Clonburris SDZ,
Dublin 22

Ronan Mac Diarmada & Associates

ADDITIONAL INFORMATION RESPONSE

November 2022

Play Area Location Plan

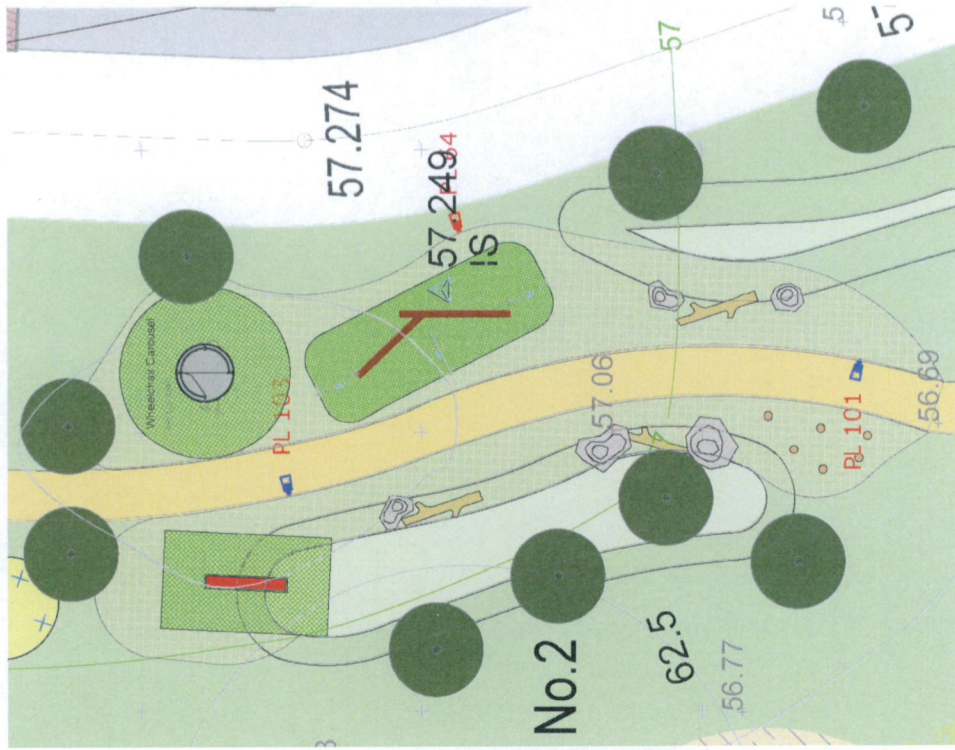
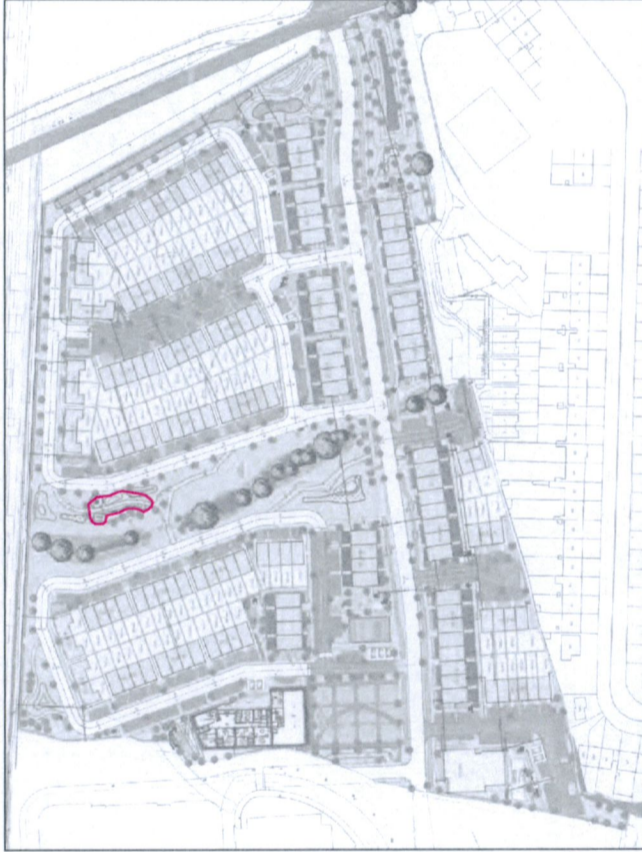
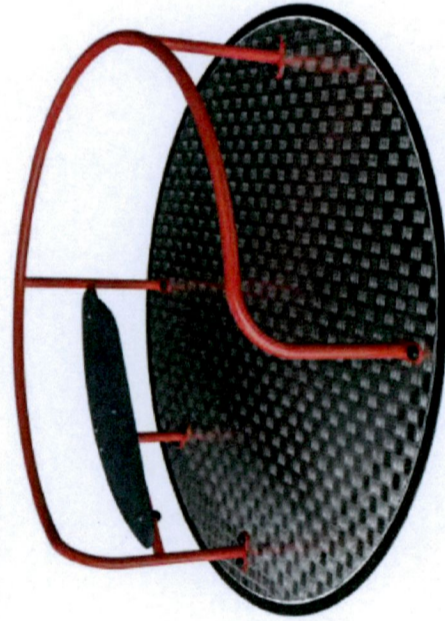
Details of all play items and natural play features to be provided and agreed with SDCC Public Realm Section.

Please see details attached.
